Subject: Proposed exterior design change to 211 S. Bedford St. apartment building (item #2 on 2/20/13 UDC agenda)

APPLICATION FOR
URBAN DESIGN COMMISSION
REVIEW AND APPROVAL

PROJECT ADDRESS: 211 SOUTH BEDFORD STREET

PROJECT
 Aspen Court
 Apartments
 211 South Bedford Street
 Madison, Wisconsin 53703

NORTHWEST ELEVATION AS APPROVED

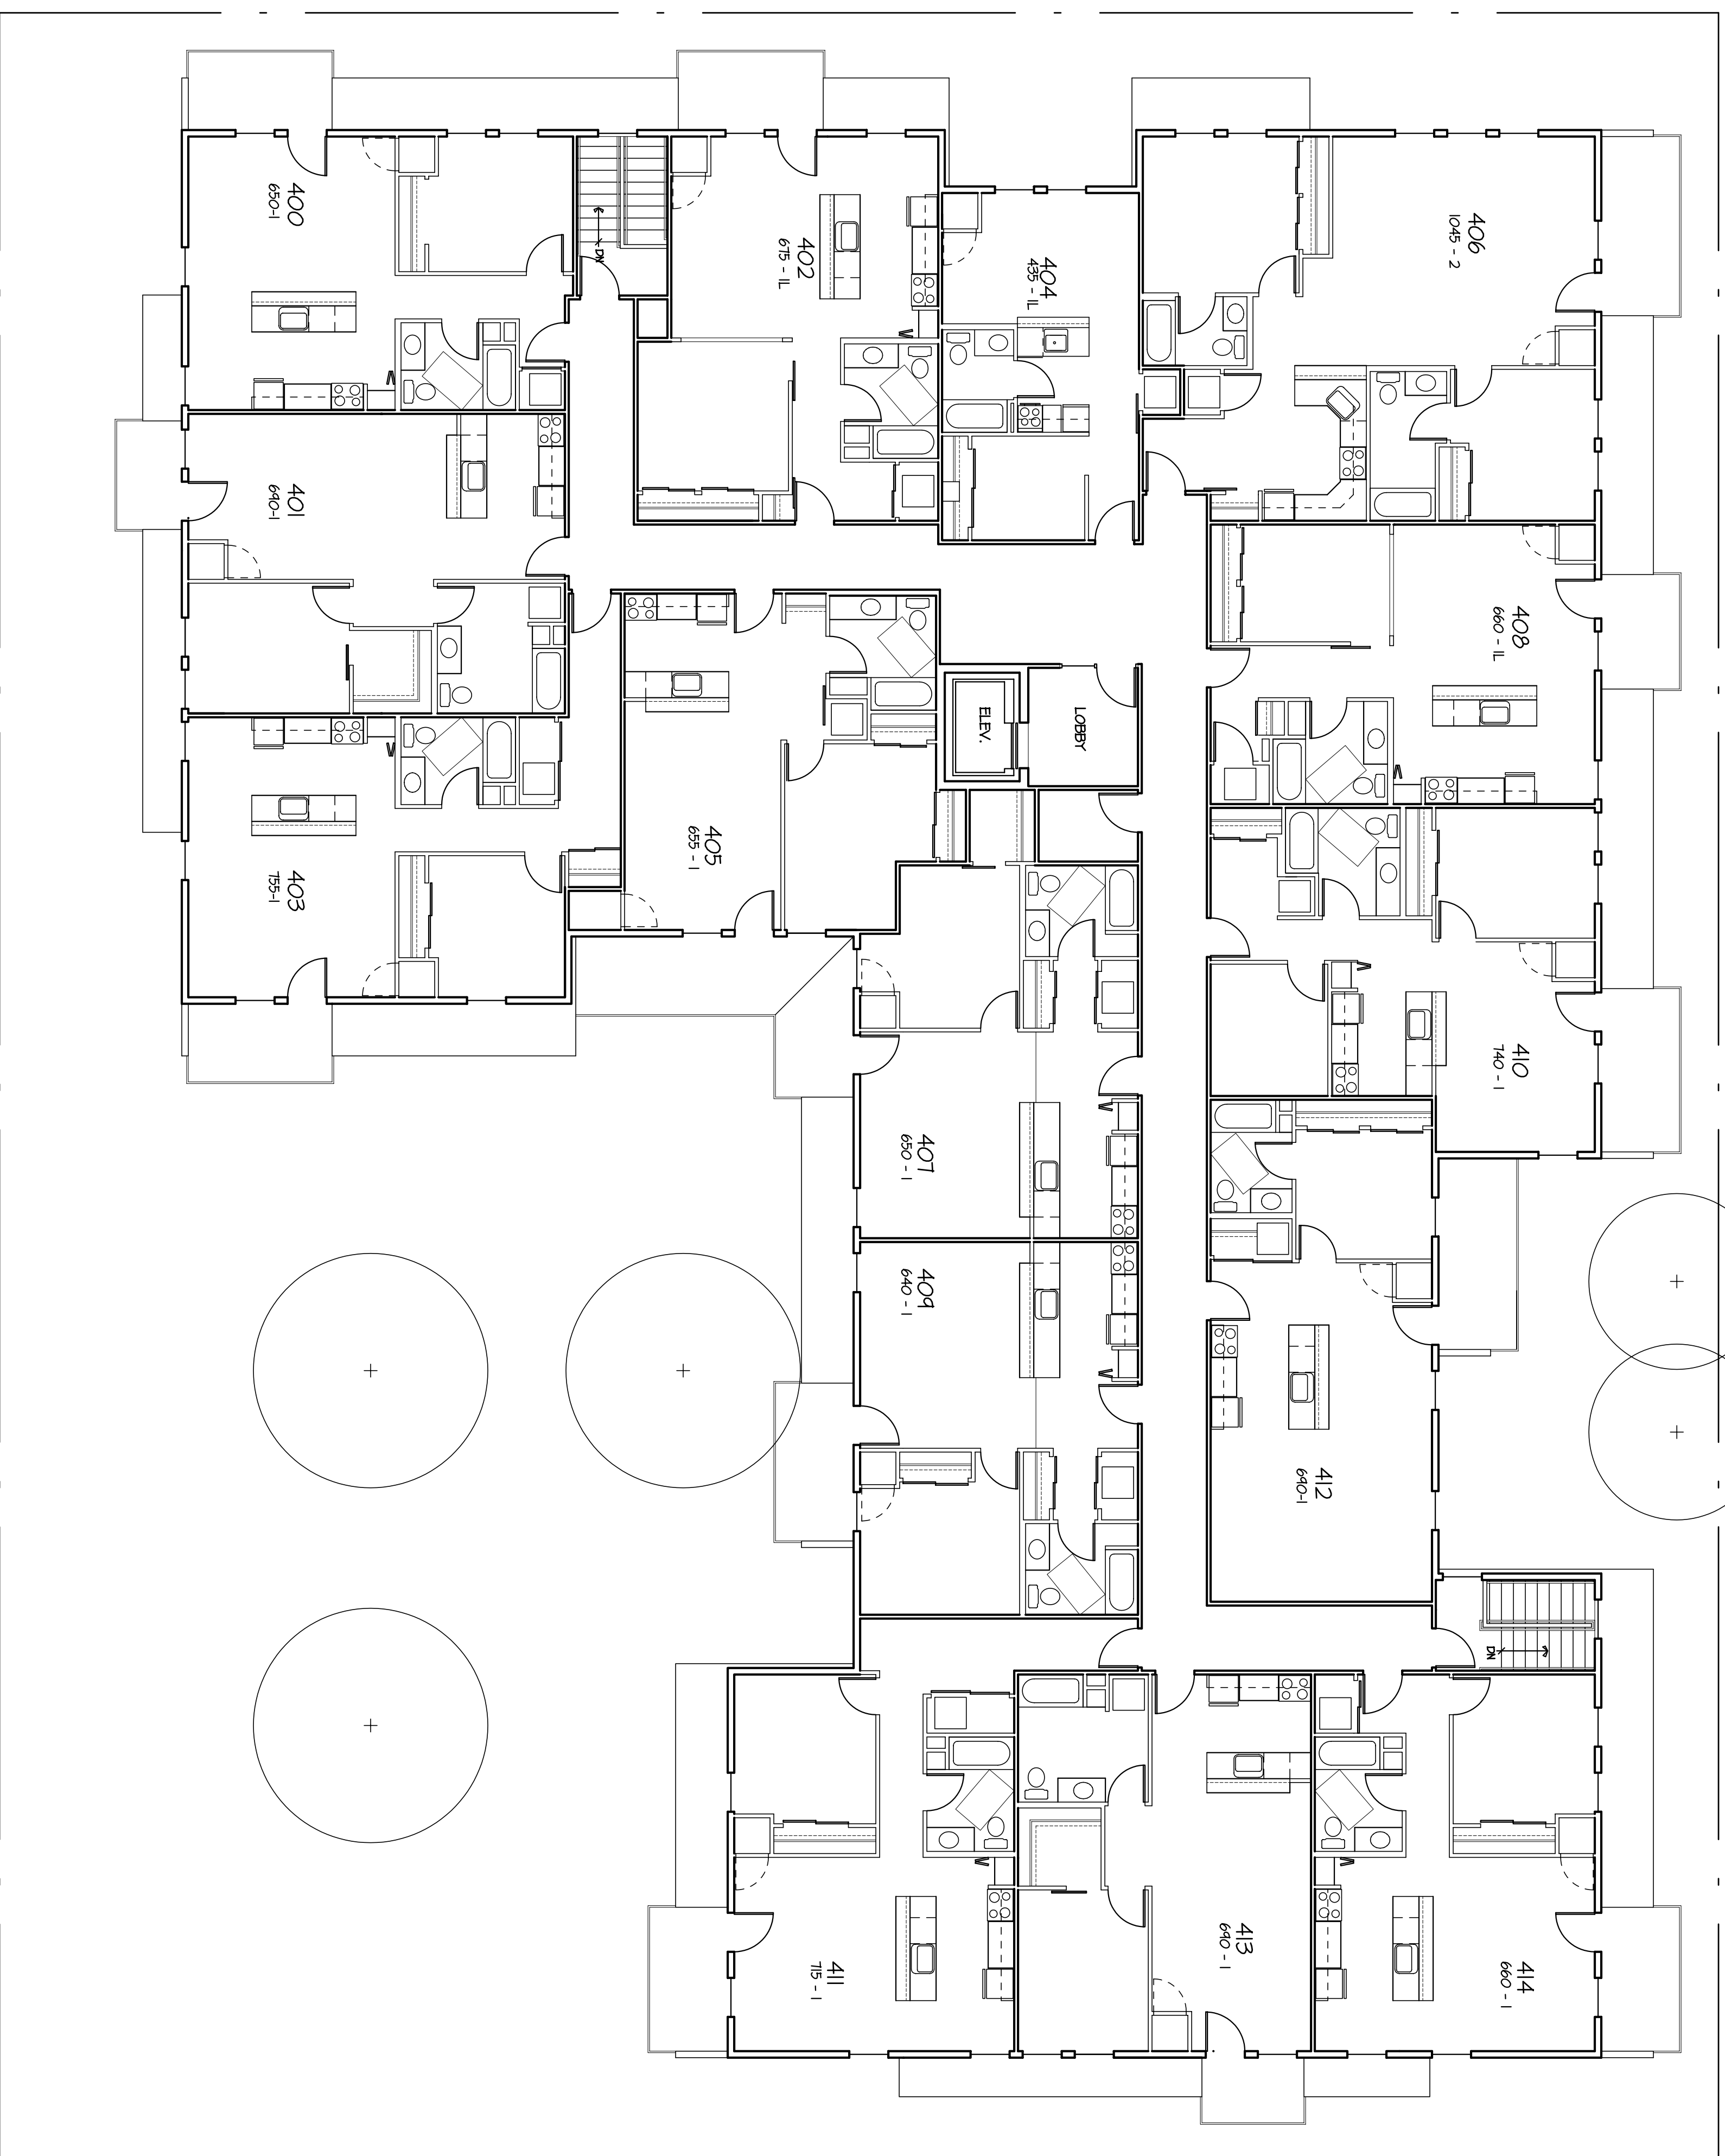
I have reviewed the documents available on the City web site and believe they do an inadequate job of conveying the designs, both current and proposed. Consequently I have attached a partial rendering to this email as a reminder of what was approved last year.

First, that the balconies were not mere attachments to the building, but would be complimentary to the volumetric design of the adjacent forms in this building. To achieve this, the balconies were conceived of as semi-recessed tubes of space,

extending visually between floors by using a baluster design that gathers space together into a vertical volume. The railings were not thought of as just a barrier meeting minimum code requirements, and the balconies were not meant to be appendages suspended from the building.

Second, the original railing design was intended to provide the balcony occupants with views out but also with some privacy by use of the closely spaced vertical slats of the steel grating material used as the railings. This would also have the effect of lessening the visibility of the various objects placed on the balconies by occupants.

As a member of the Bassett neighborhood steering committee which met to review this project, I am opposed to the proposed deck railing design modification which the developer intends to present at the February 20, 2013 UDC meeting.

When the project was presented to us in April of 2012, the architect stated that the material to be used for the deck railings would be ¼" galvanized steel grating spaced at 1 to 1 ½". The stated advantages were that this design would provide an "industrial" look (in keeping with Bassett's historic past as a warehouse district). Additionally, this type of railing surround would afford more privacy for residents as well as screening residents' personal belongings from the street view. Moreover, the steel would not require painting and thus would not require the ongoing maintenance of a painted metal railing. The members of the steering committee felt that, for all of these reasons, the original design was appropriate and pleasing from an aesthetic standpoint.

It is my understanding that the architect still prefers the original design, but that the developer has requested a change for reasons that are unclear (perhaps cost is a factor?) The revised design lacks all of the advantages of the original design, stated above.

Since this building is in a prominent corner location (S. Bedford and W. Doty Sts.), in a part of the Bassett district that is currently undergoing considerable residential revitalization, I think the neighborhood is deserving of a design that uses quality materials with an innovative approach, as reflected in the original deck railing design. I hope that you will not approve the requested design change.

The attached file has a page with the original design and a page with the new proposed design. I confirmed with John Sutton that the change is intended for all of the decks but only the one elevation drawing has been prepared to illustrate the change.

John indicated that the change came about due to the owner's concern with using a nonstandard product for the railing. (The original material is a galvanized steel grating) The new railing is aluminum which will be painted.
